Service Letter No. 340

SUBJECT: Sealing of Fuel Cell Filler Neck Riveted Seam

MODELS AFFECTED: PA-23-250 Aztecs, Serial Nos. 27-1 to 27-153  
inclusive

SERVICE LETTER #340

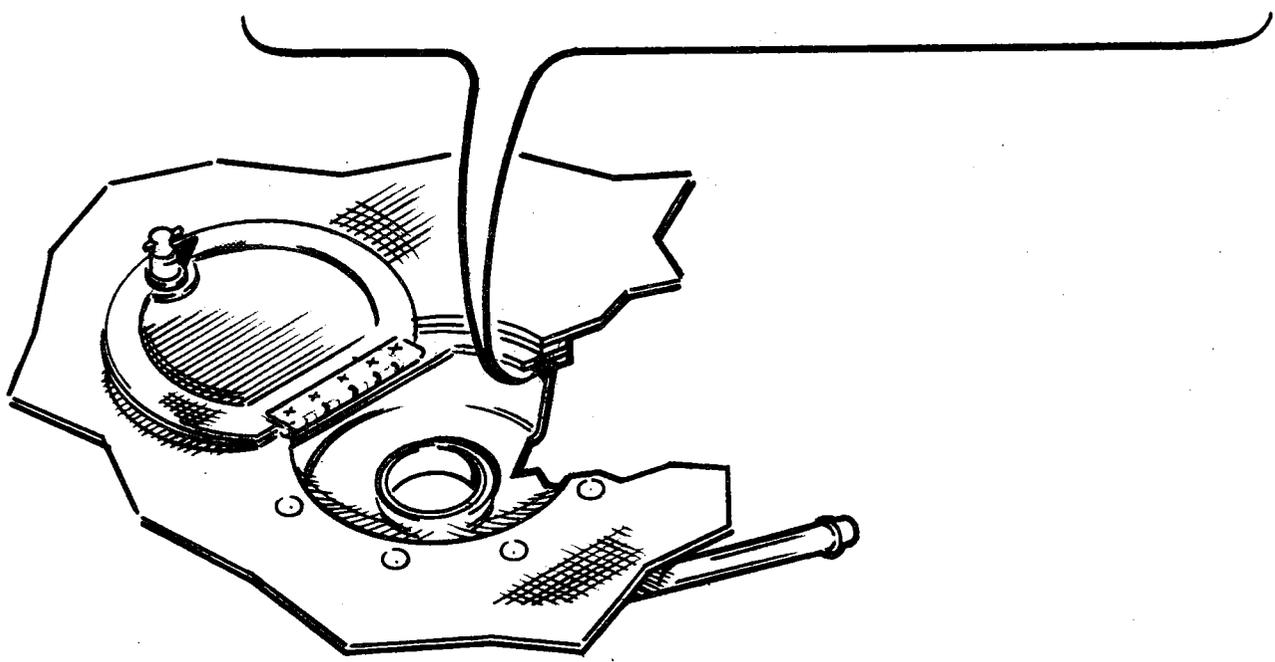
It is requested that an application of Permatex No. 3 be applied to the riveted seams of the four (4) fuel cell filler necks as shown on the sketch on the reverse side of this letter.

APPLY FILLET OF PERMATEX #3
